CITY OF TAMPA

ADDENDUM 6

September 28, 2018

Contract 15-C-00044; Louisiana Pump Station Rehabilitation

JACINTO CARLOS FERRAS P.E. #49454 DESIGN DIVISION HEAD WASTEWATER DEPARTMENT	No.	DATE	REVISIONS	DES: D.R.	CITY of TAMPA WASTEWATER DEPARTMENT	LOUISIANA PUMPING STATION REHABILITATION NOTES	SHEET
	3			DRN: BB			G-3
	2			CKD:			
	⚠	9/10/18	ADDED NOTE	DATE:

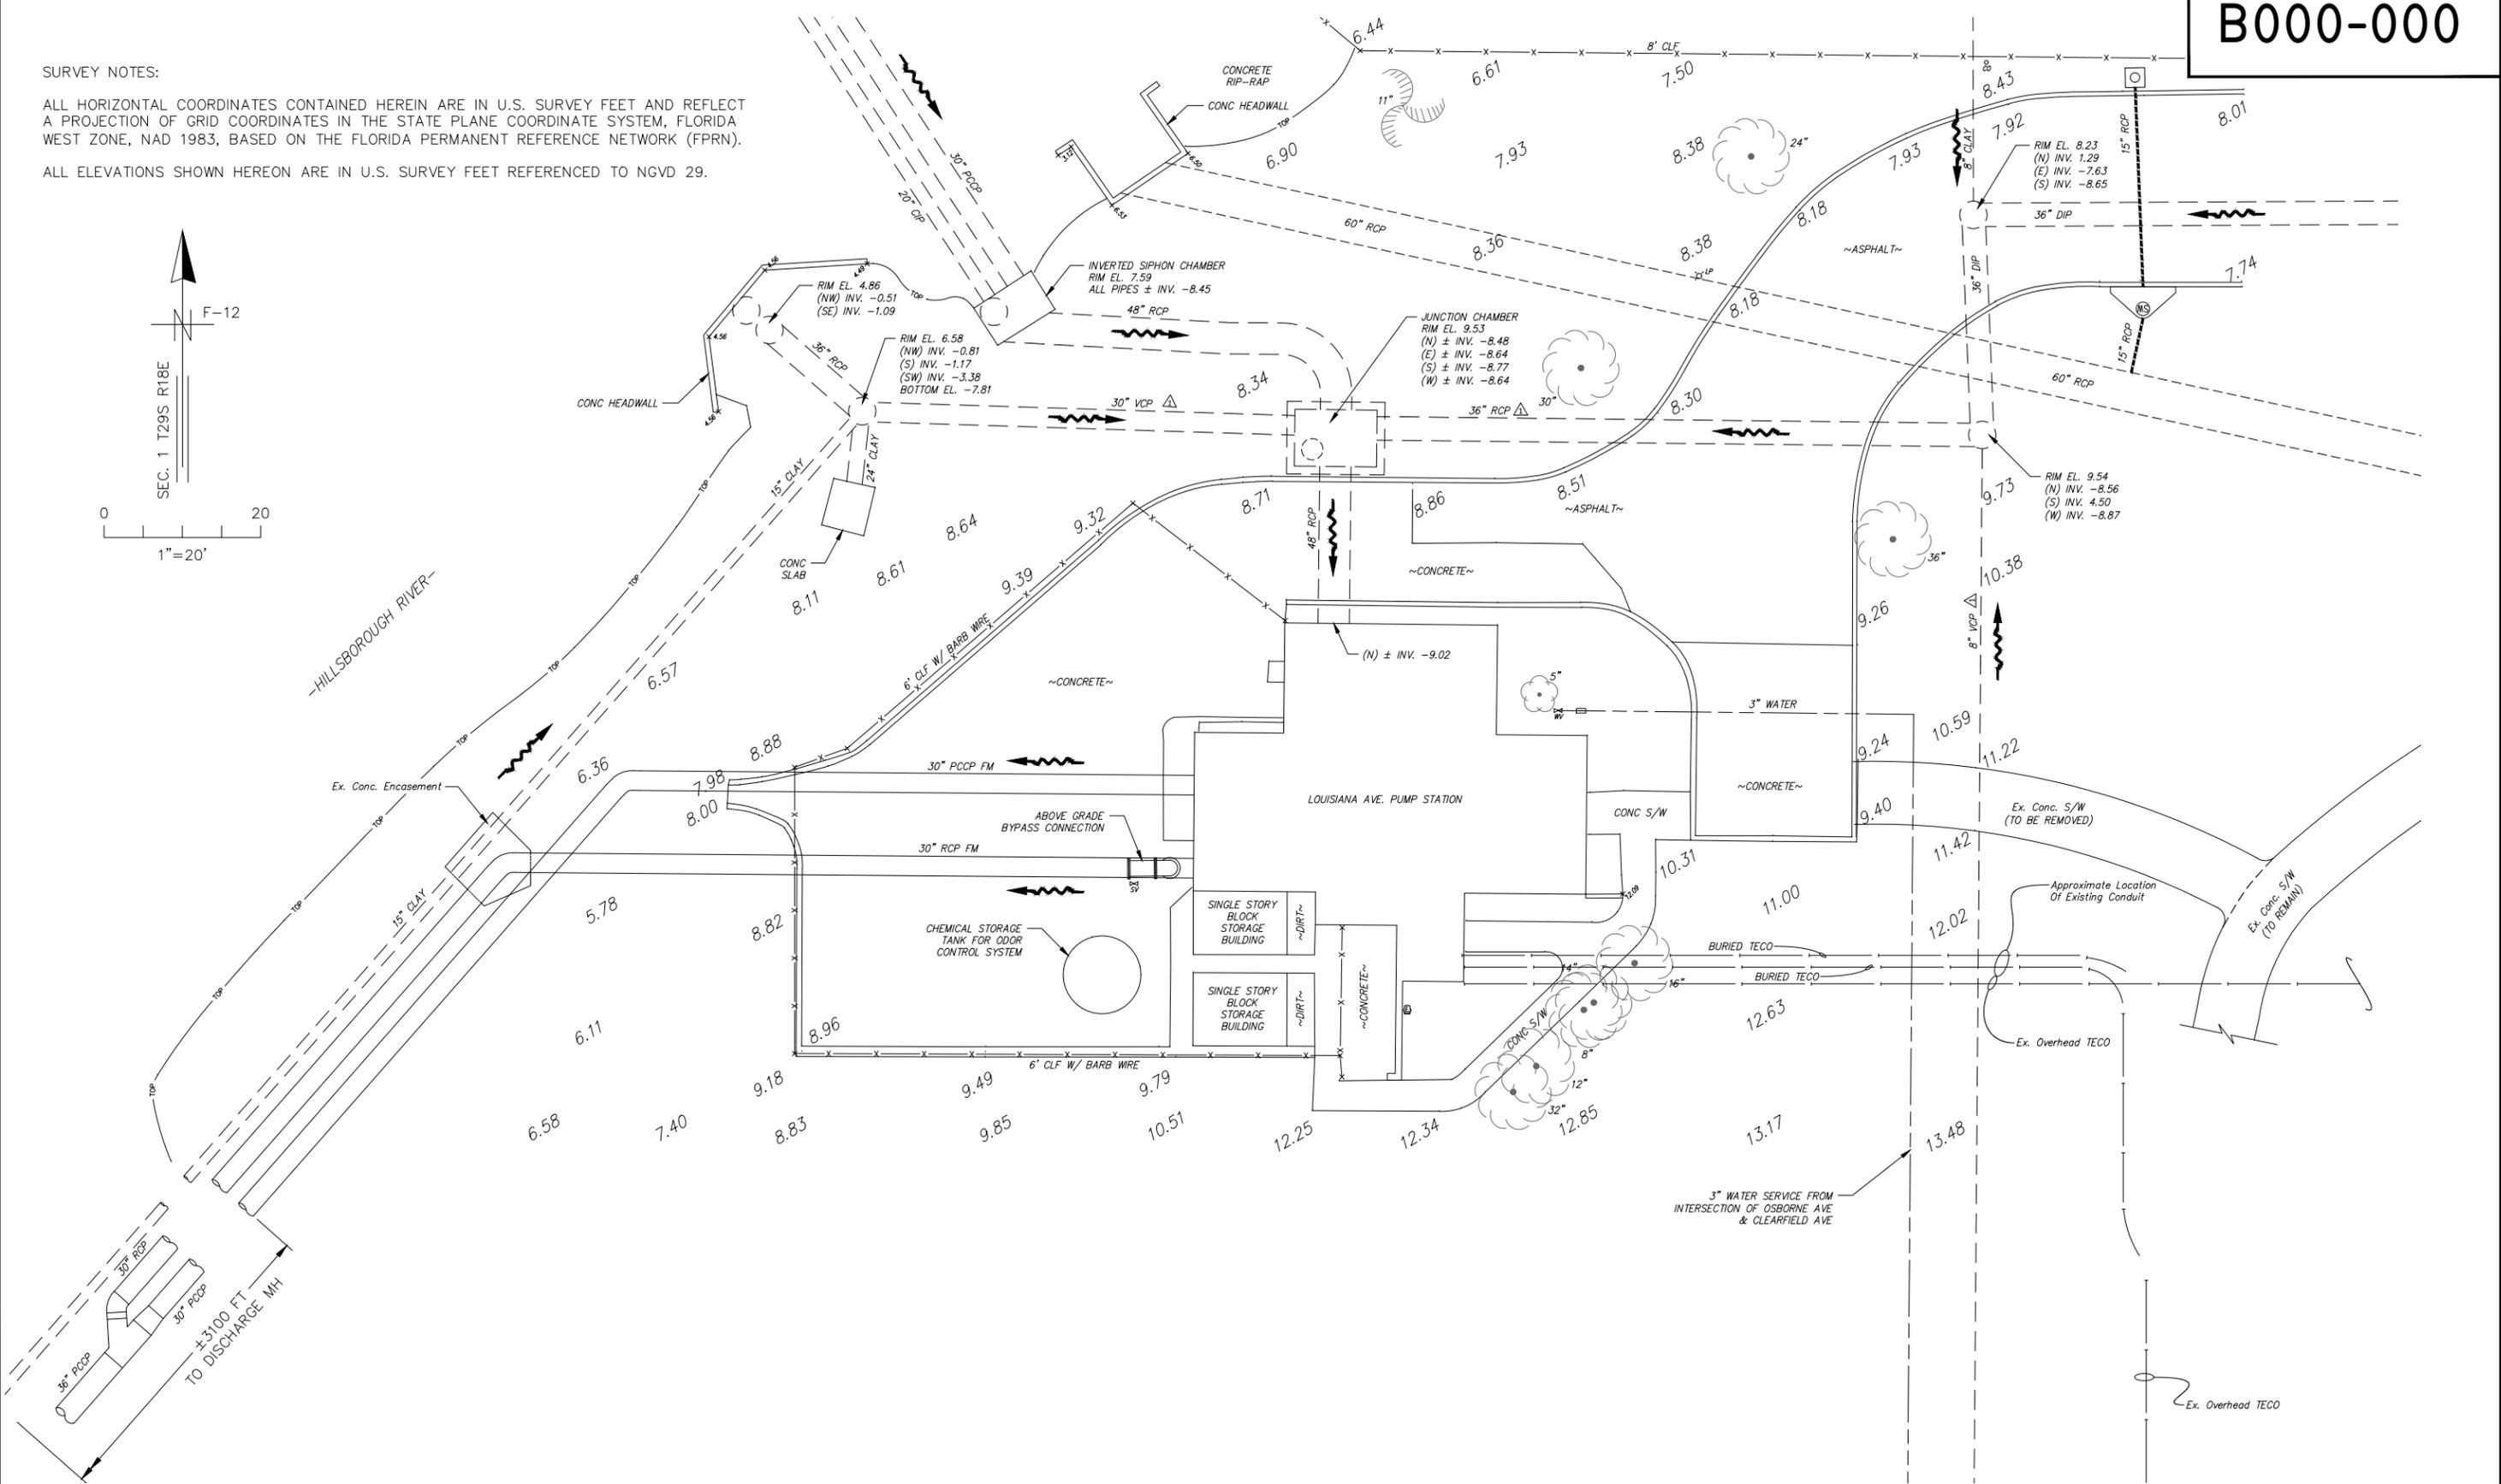
⚠ CONTRACTOR IS RESPONSIBLE FOR FILLING THE GENERATOR SUBBASE TANK WITH FUEL AND THEN REFILLING IT AFTER THE LOAD BANK TEST IS COMPLETE.

SHEET
 C-1

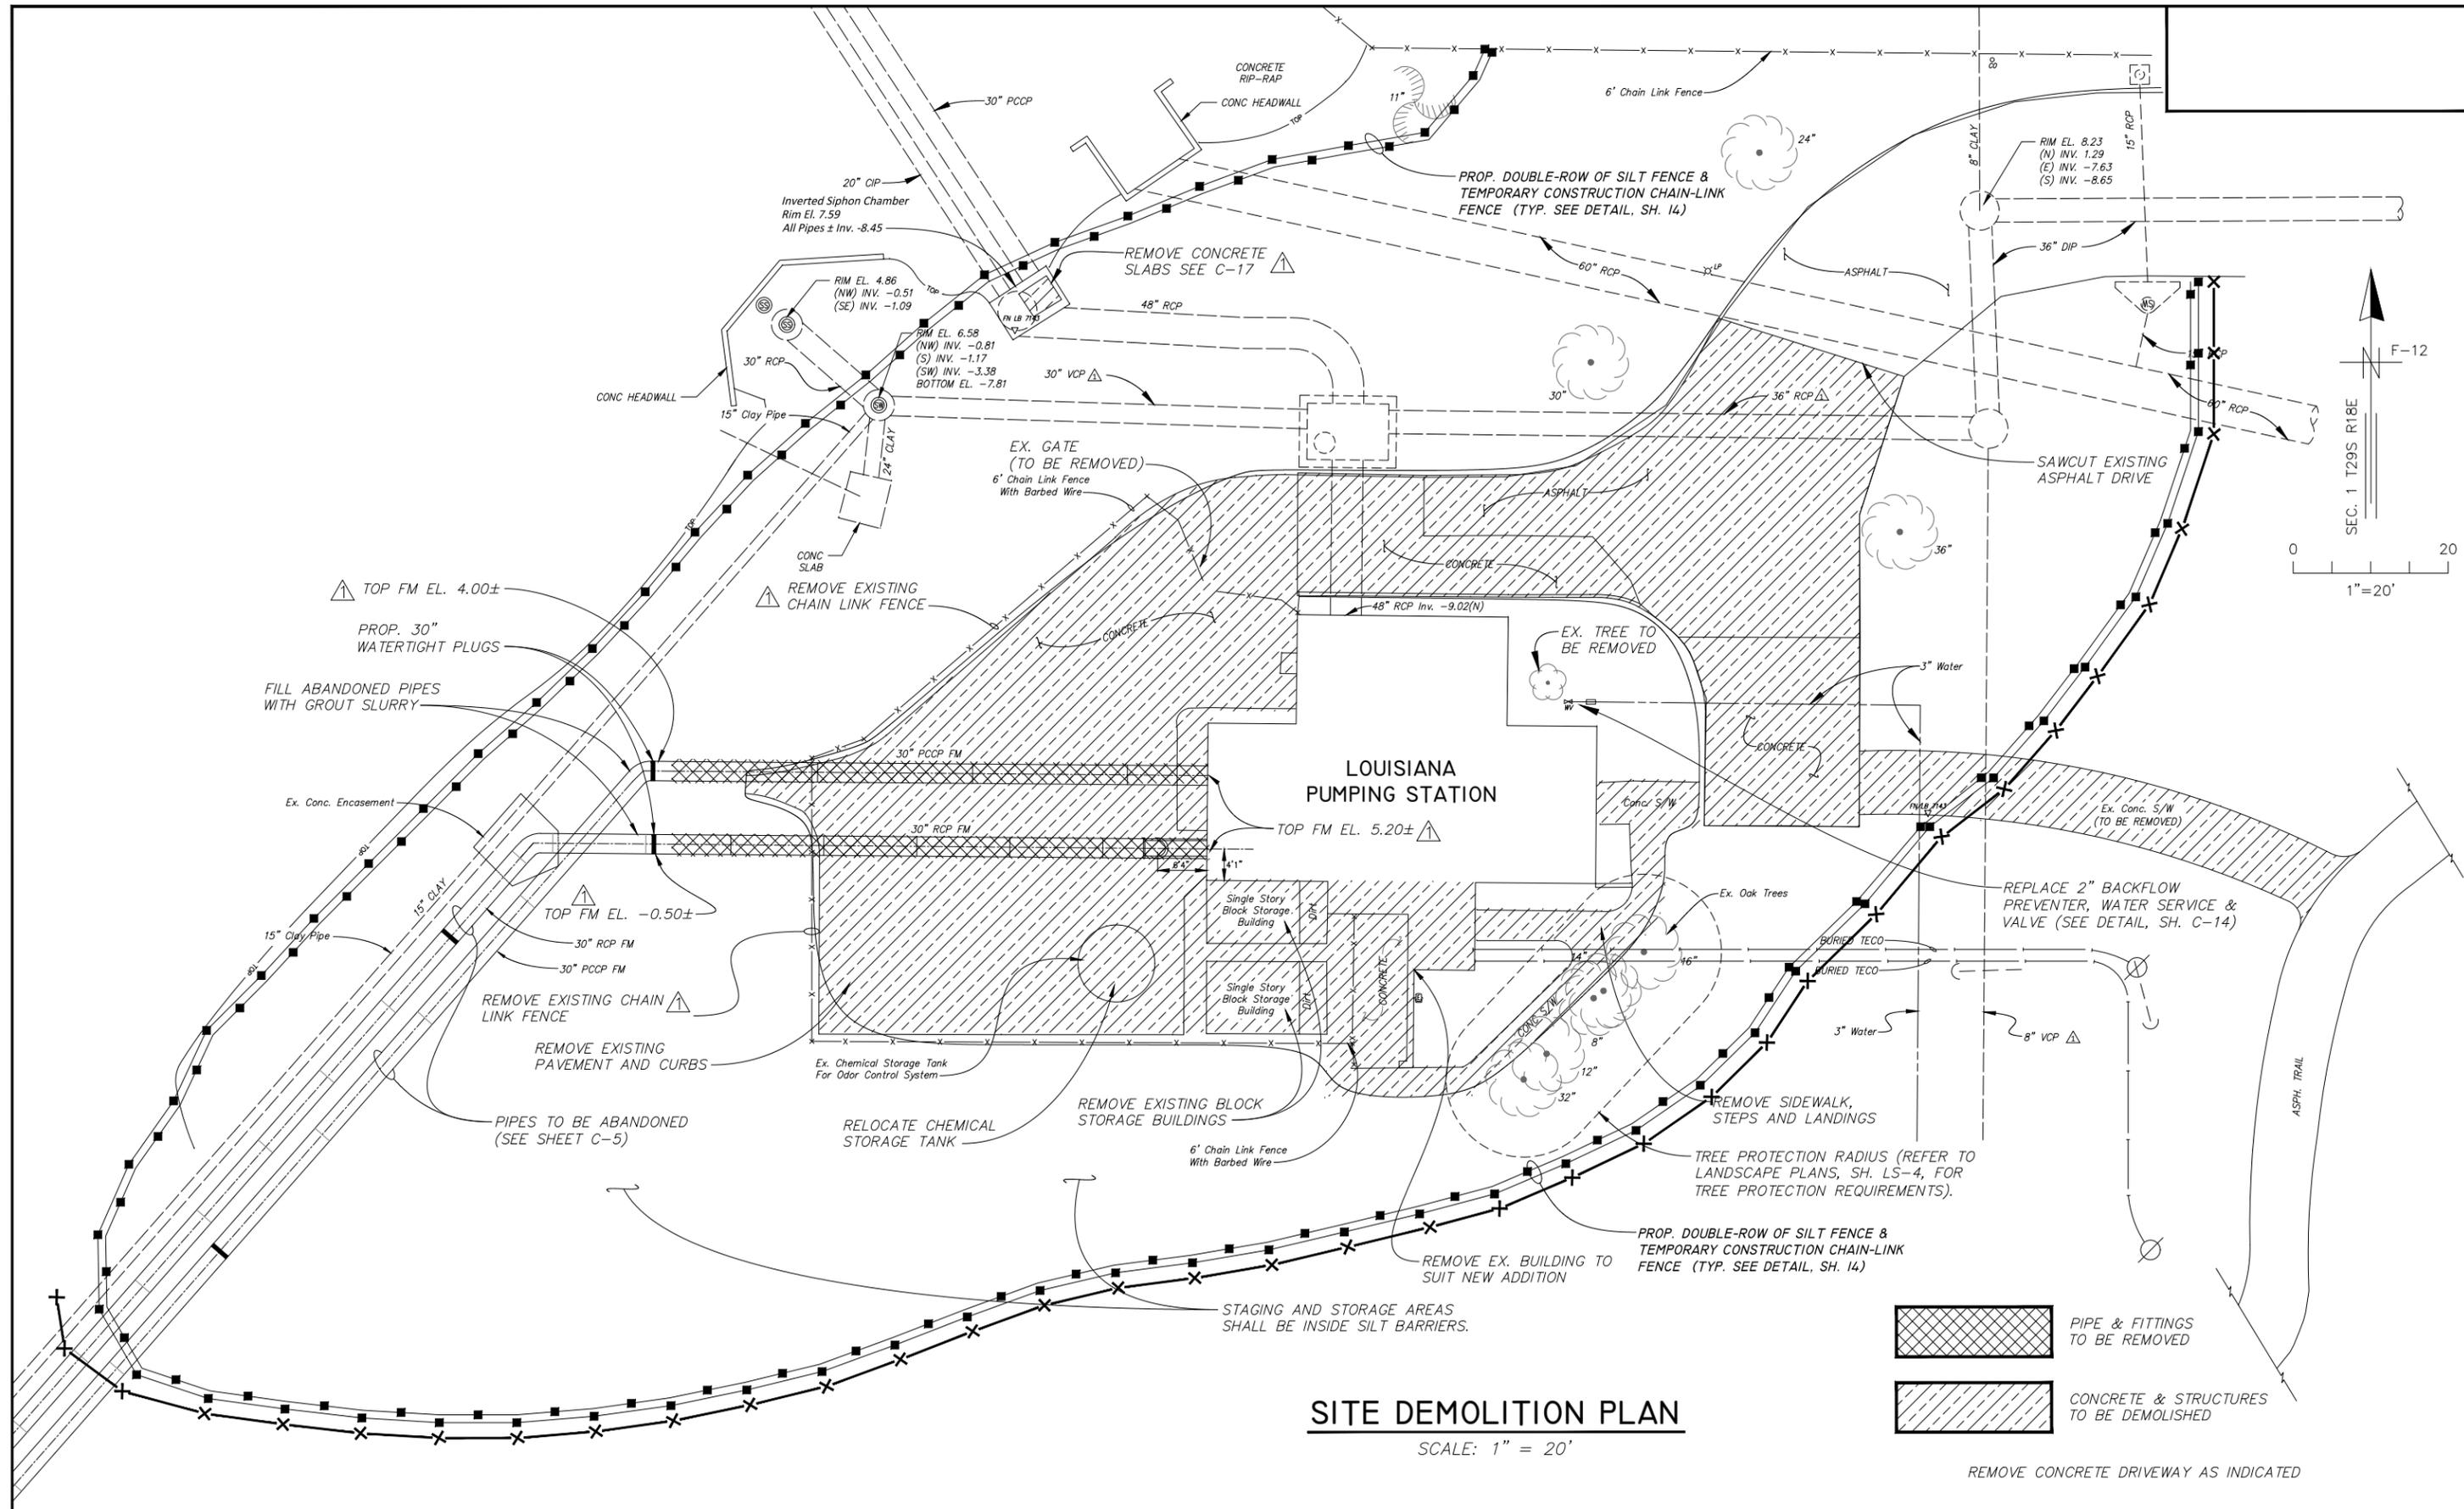
No.	DATE	REVISIONS
3		
2		
1	9/14/18	EX. PIPE MATERIAL

SHEET
C-3

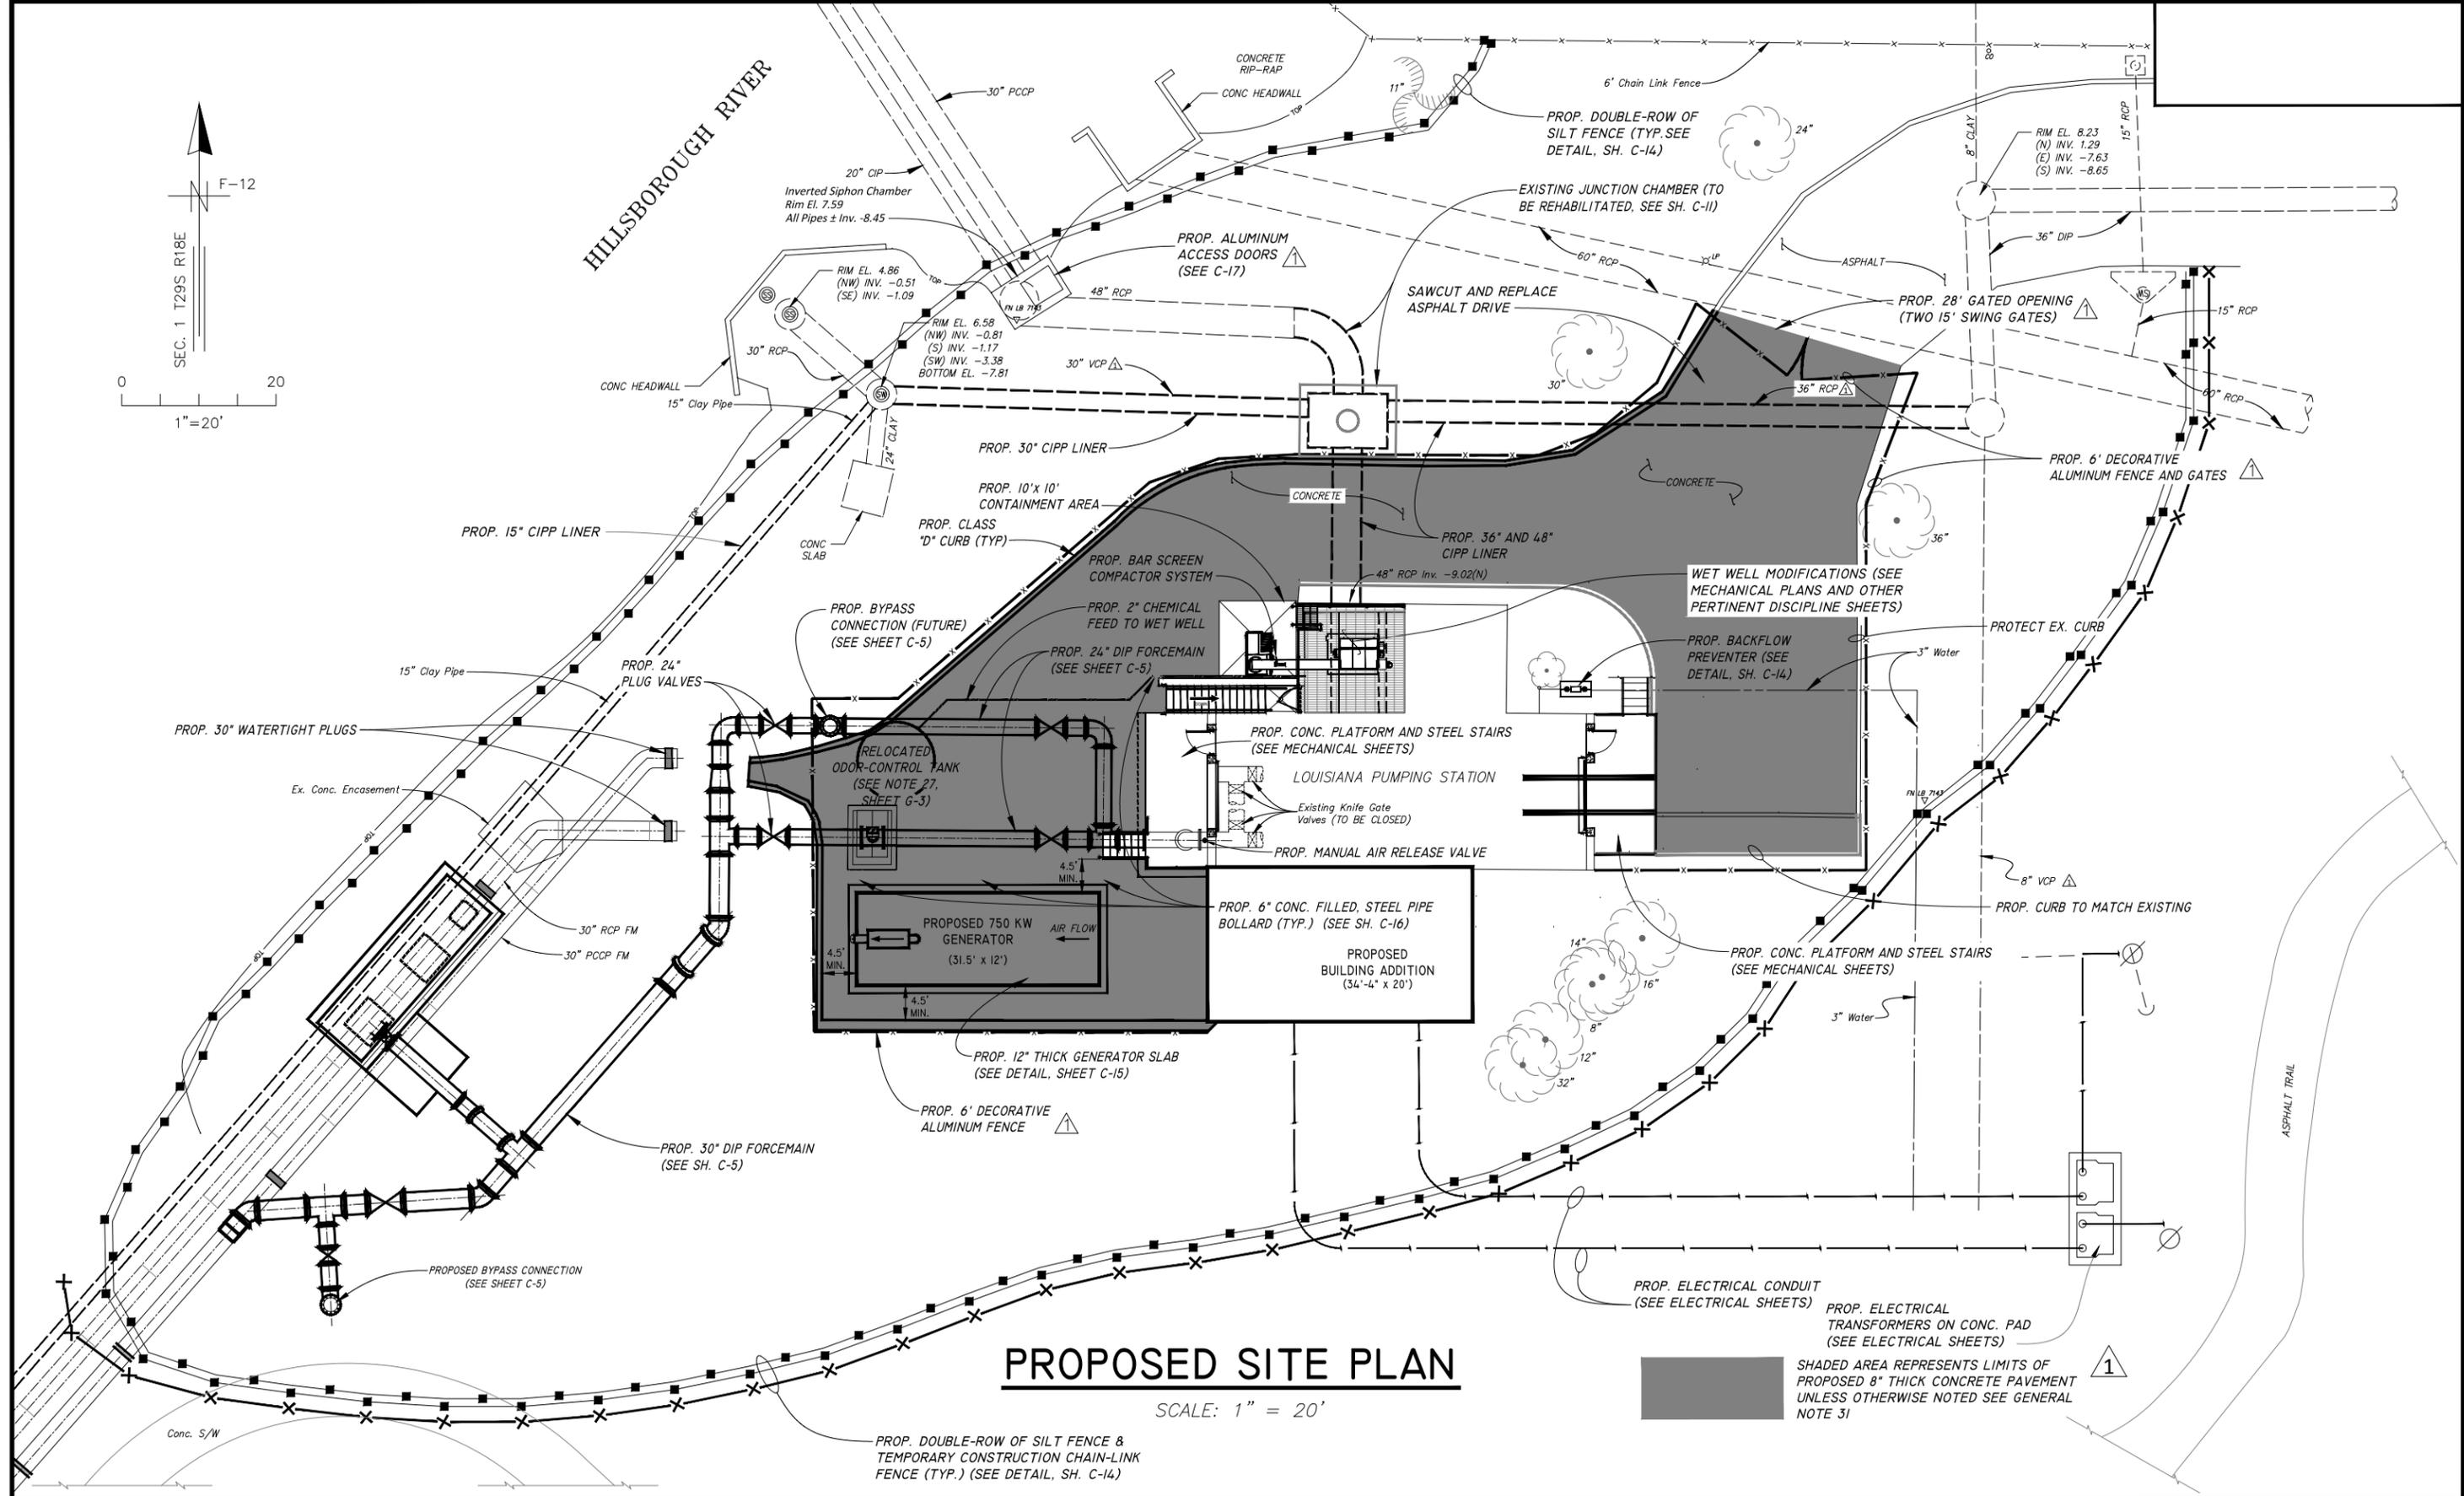
No.	DATE	REVISIONS
3		
2		
1	9/10/18	ADDENDUM - FM ELEVATIONS / FENCE NOTE / ALUMINUM COVER / EX. PIPE MAT'L
